RECOMMENDATIONS

B-BLOCK - "THE PLAZA" OPEN SPACE

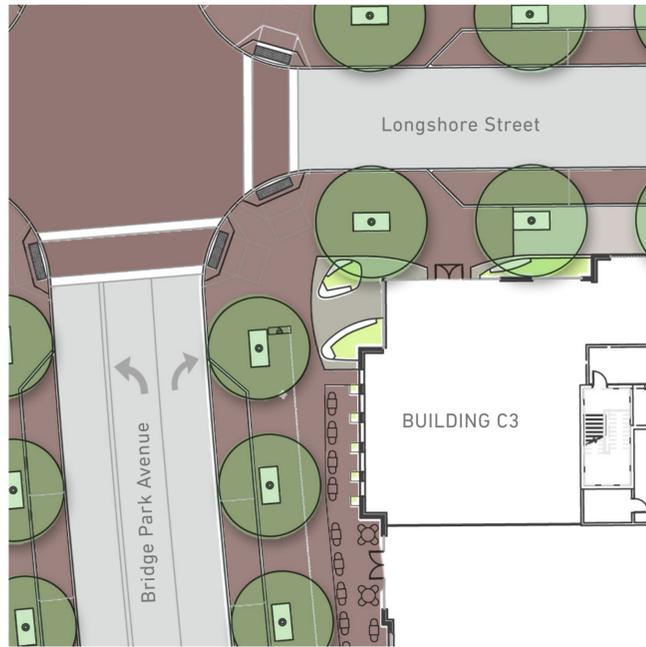
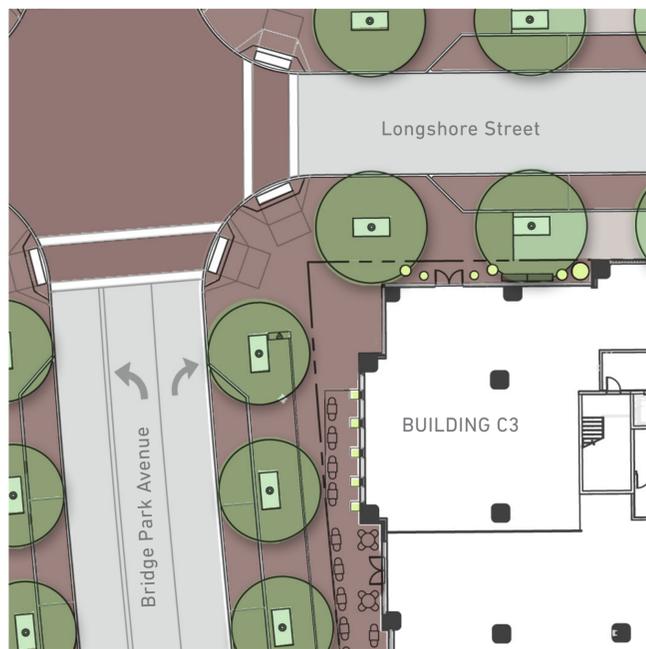
Paving changed to brick with contrasting pattern to adjacent sidewalk brick. Planters and benches remain.

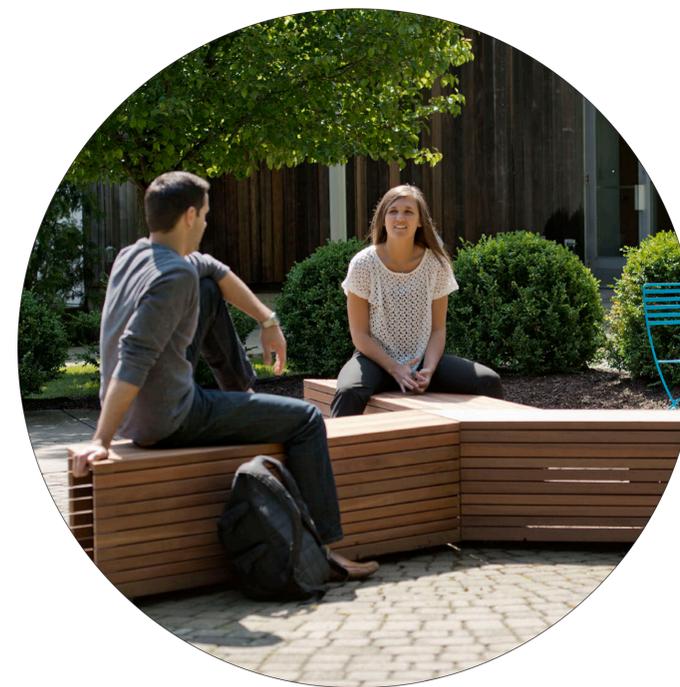
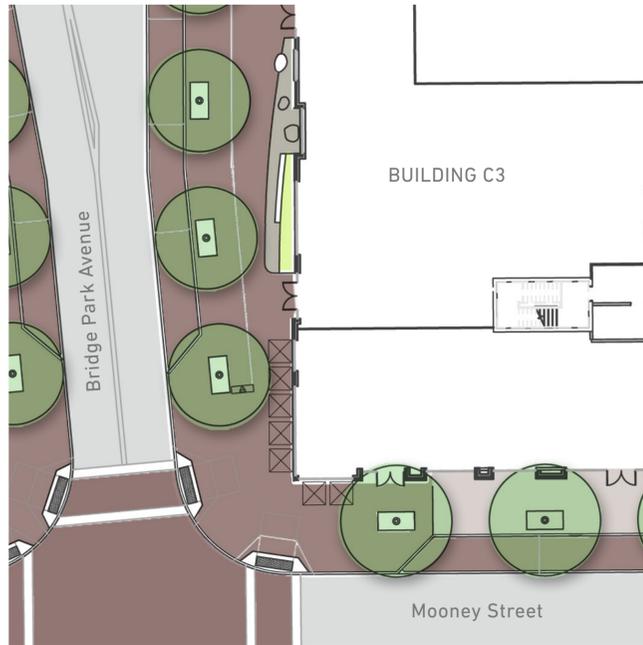
Paving changed to brick with contrasting pattern to adjacent sidewalk brick. Sculptural planters clustered around entry and benches.

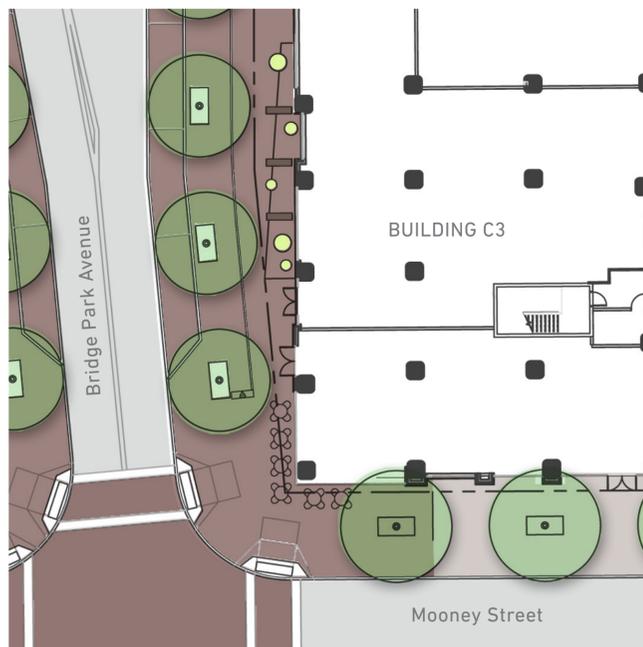
Paving changed to brick with contrasting pattern to adjacent sidewalk brick. Sculptural planters clustered around linear benches that follow grade change.

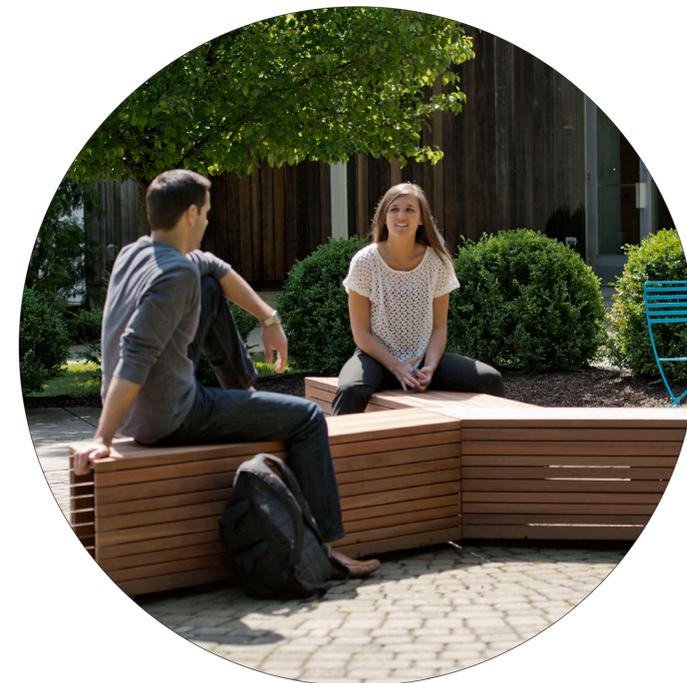
Paving changed to brick with contrasting pattern to adjacent sidewalk brick. Planters clustered around sculptural bench.

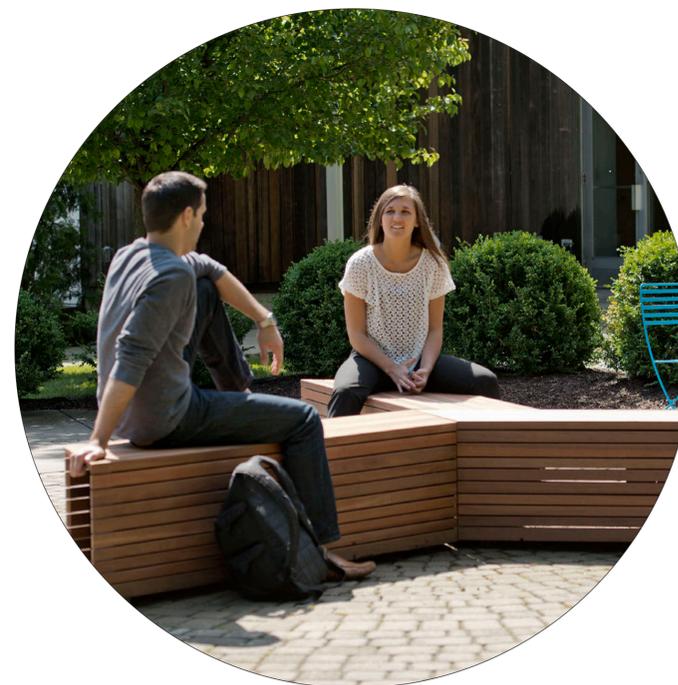
Paving changed to brick with contrasting pattern to adjacent sidewalk brick. Planters clustered at corner replace the boulder planters. Sculptural bench remains. Rectangular planter remains at building entry.

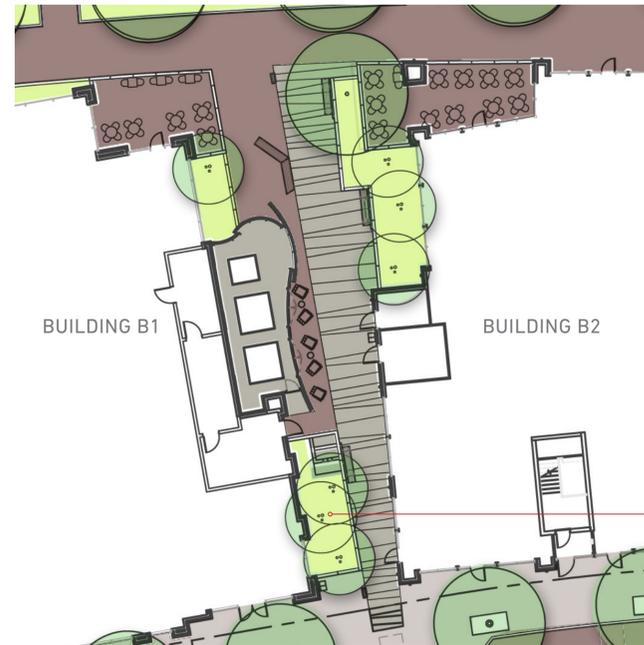
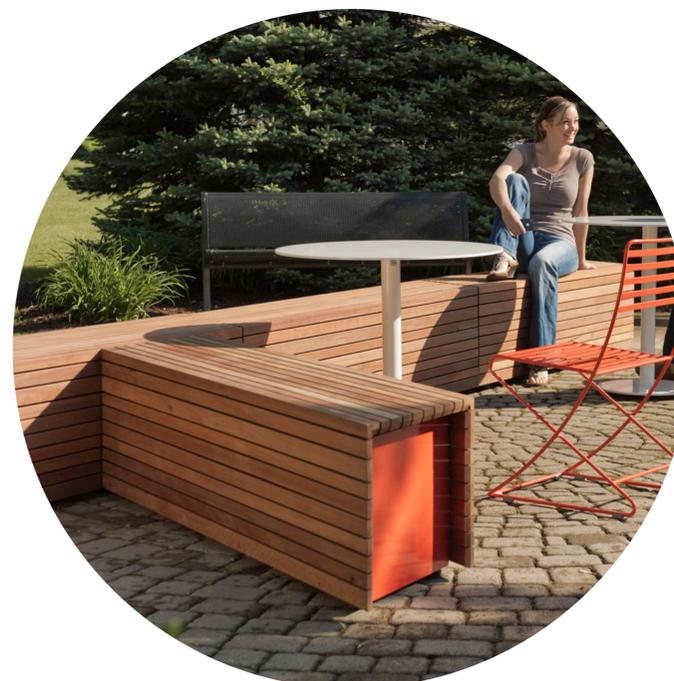
Planter area is relatively insignificant to allocate significant resources and construction complexity for little return. Requesting to change the current bio-retention planter to a typical planter without bio-retention.

Brick paving to remain. Sculptural bench is flanked by clusters of planters.

PROPOSED CATENARY SYSTEM TO REPLACE THE BOLLARDS AND ILLUMINATED HANDRAILS

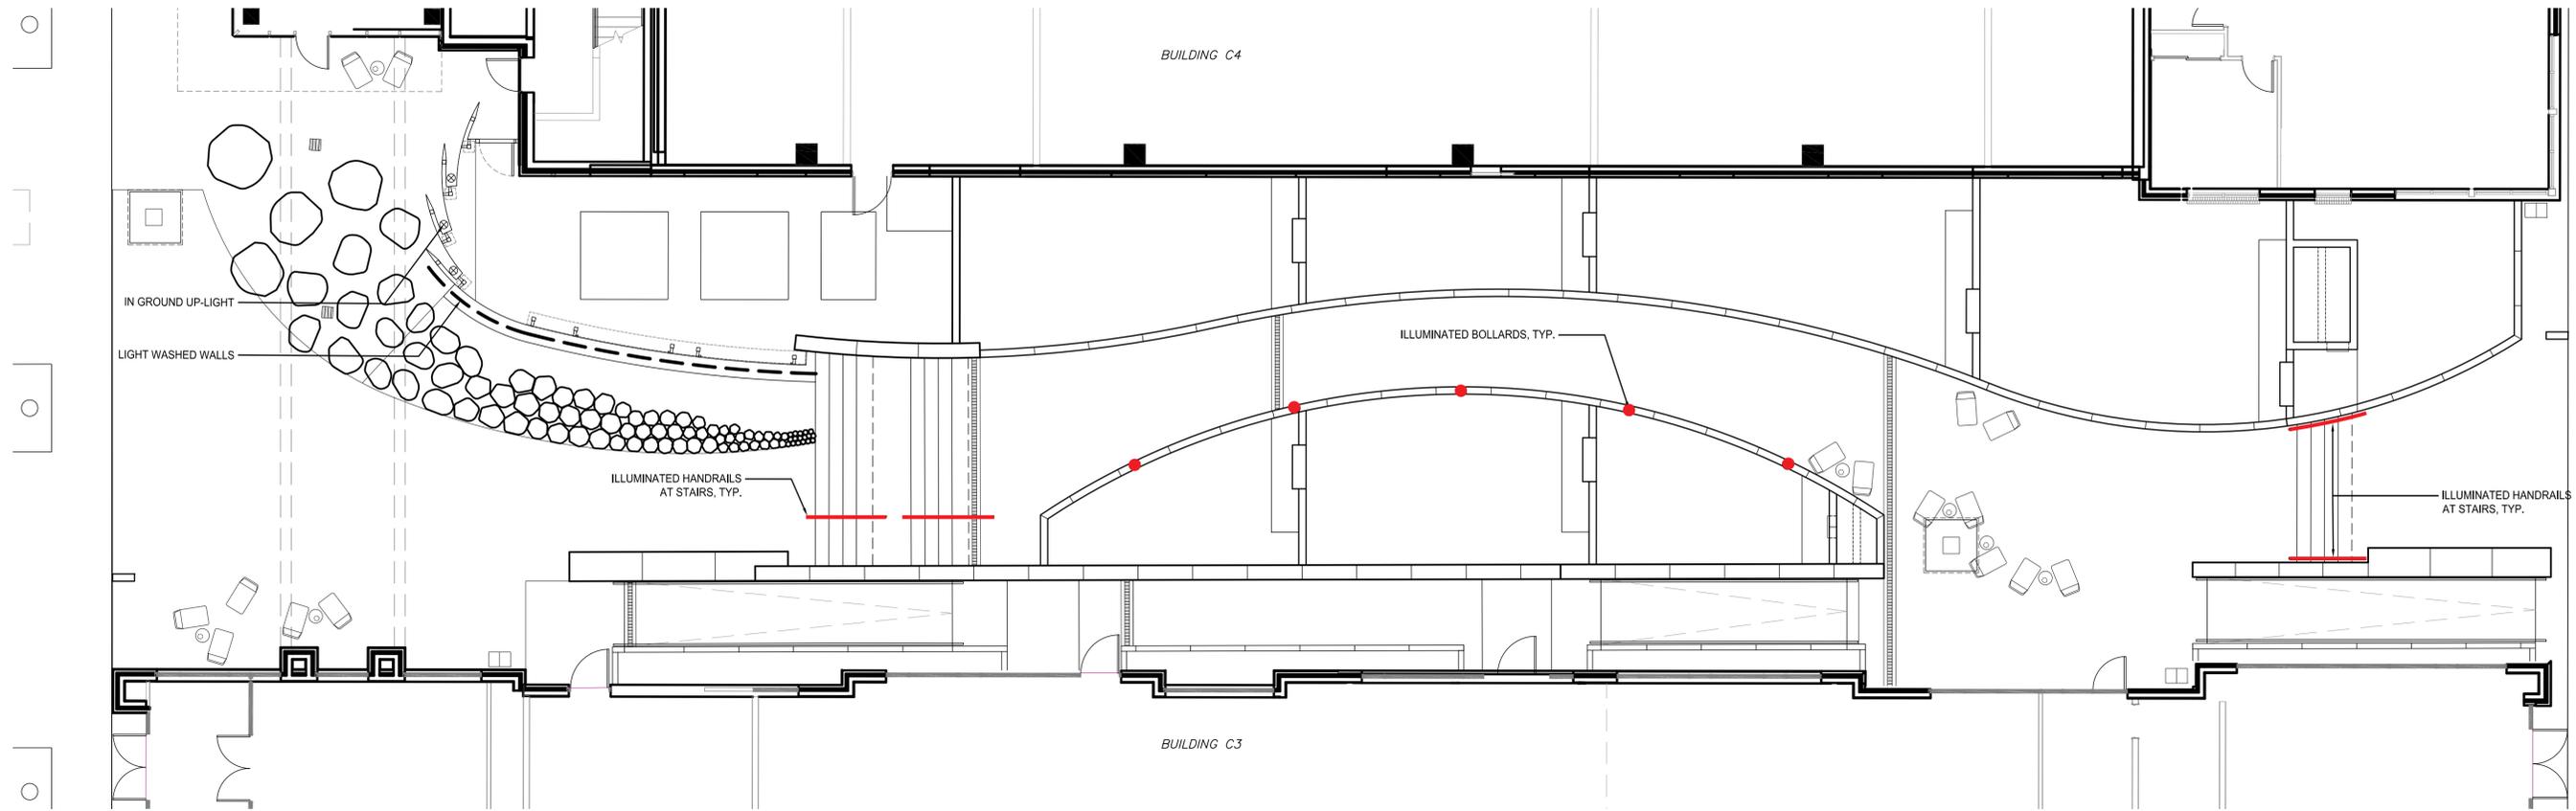
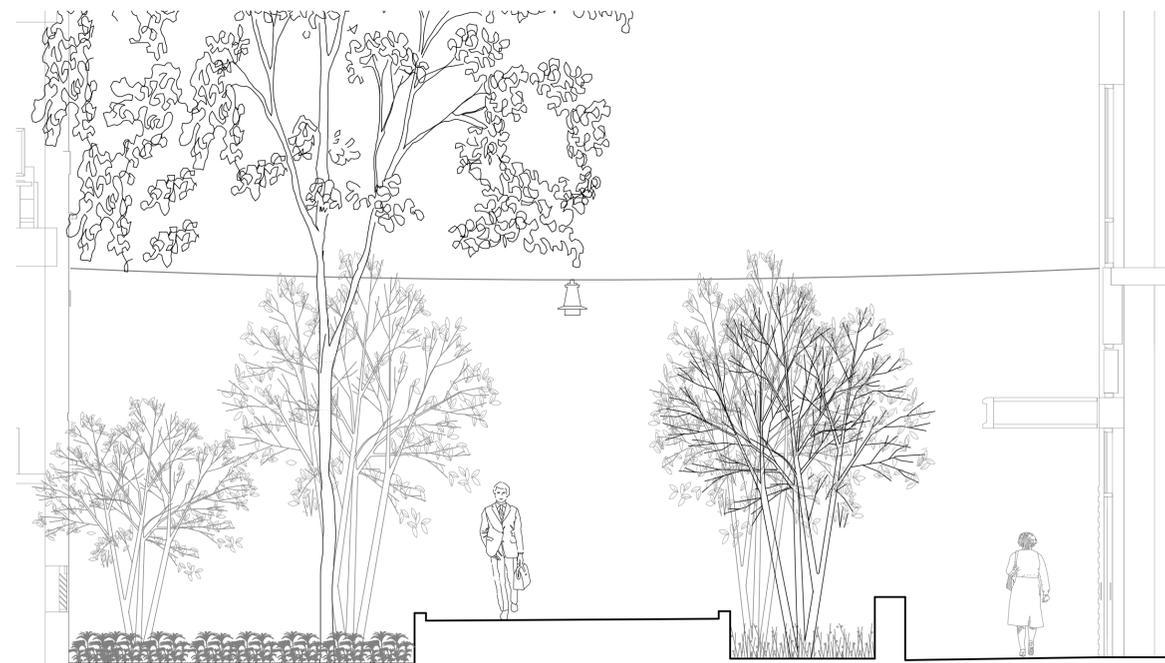
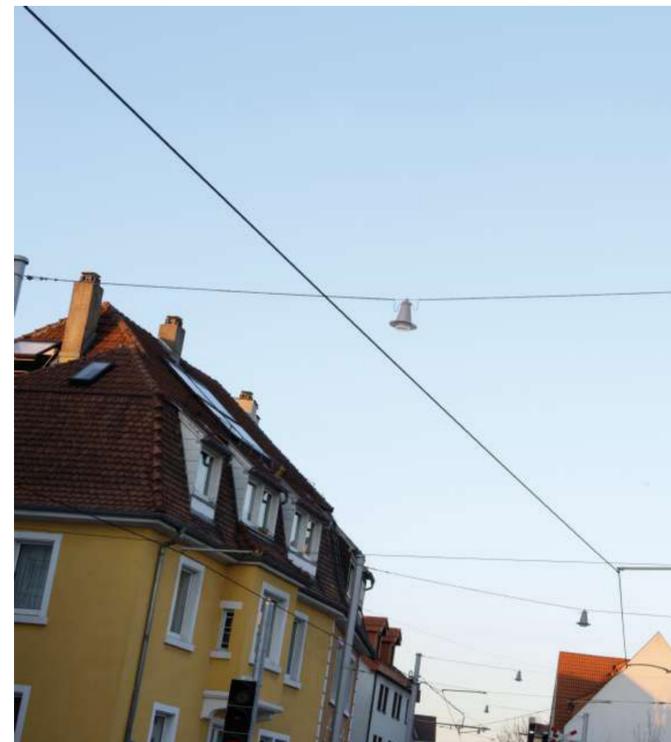
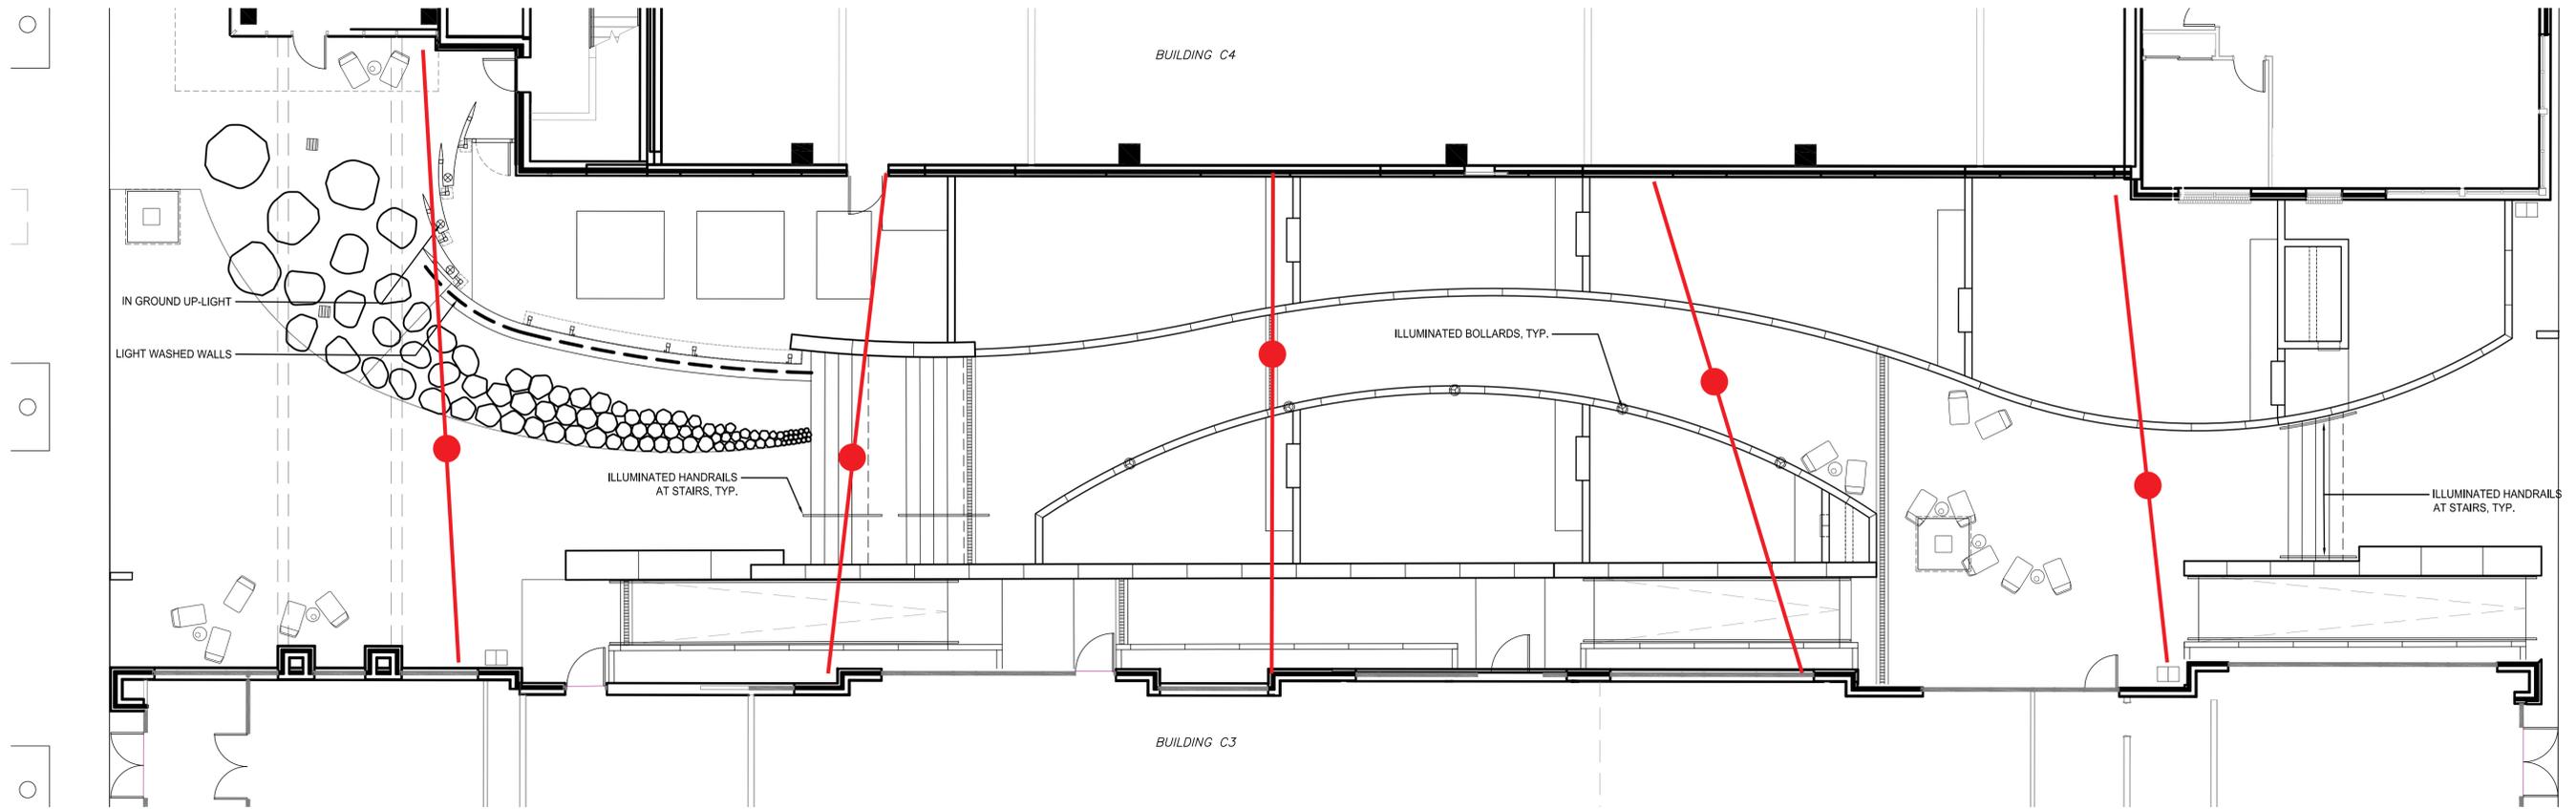
The proposed changes are to eliminate the illuminated handrails and bollards and replace them with (5) Hess Pendo catenary system lights suspended from the adjacent buildings.

Lighting at the decorative screen wall will remain the same.
